PLANNING, ZONING, & BUILDING DEPARTMENT
PZ&B Staff Combination Memorandum: Architectural Commission and Town Council

SUBJECT: ARC-24-0011 (ZON-24-0006) 1741 S OCEAN BLVD (COMBO)

MEETING: AUGUST 28, 2024, ARCOM
SEPTEMBER 11, 2024, TC

PROPOSED EAST ELEVATION
 Scale: 1/8" = 1'-0"

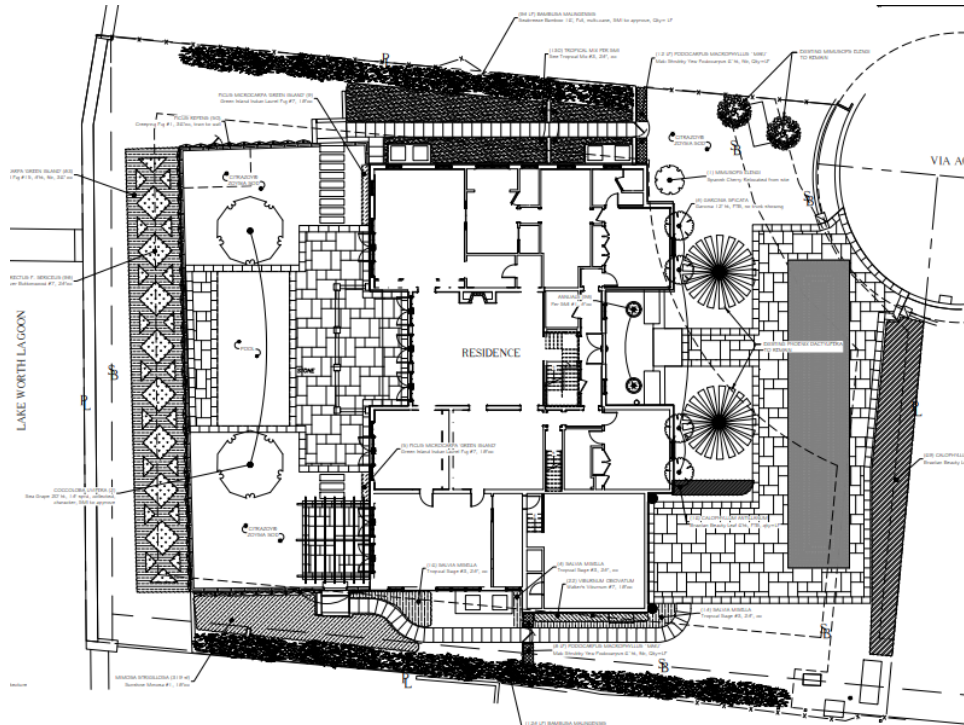
Since the last hearing the applicant has made window and door modifications, added some shutters, and redesigned the garage doors. On the front façade the enlarged transom arch and circular windows flanking the front door are proposed changes from the last iteration.

The applicant is proposing modifications and additions to this existing Palm Beach Regency style single family residence. The property is located along the intracoastal waterway at the west terminus of Via Agape. The new addition centers the second floor and is in keeping with the existing architectural style. Window and door modifications will result in more classical proportions and the rear yard will see a reduction in pool size from 50' x22' to 32' x 15'. The applicant has provided a window & door precedent study. Finishes are consistent with the existing house including smooth stucco and multi-lite wood windows.

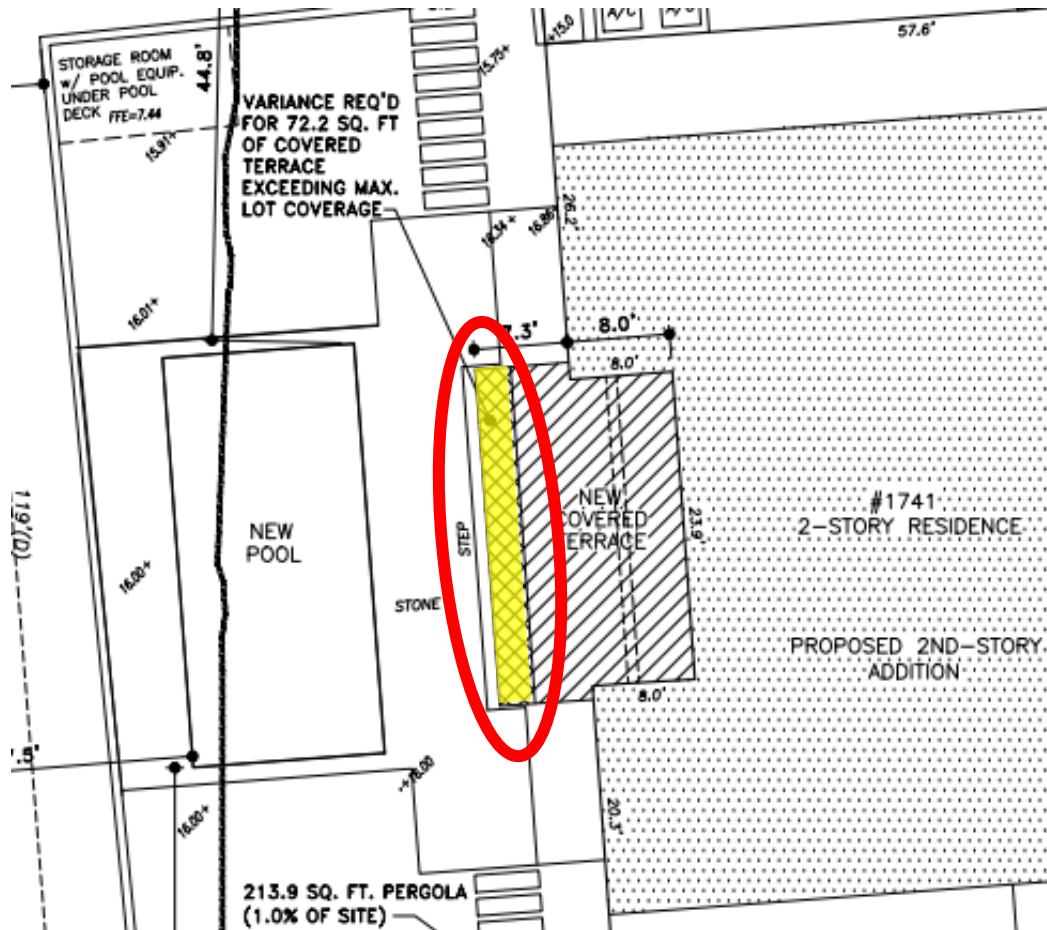
Variance #1 is being requested for the new terrace at the rear of the property to exceed the lot

coverage by approximately 72 SF, or .34%.
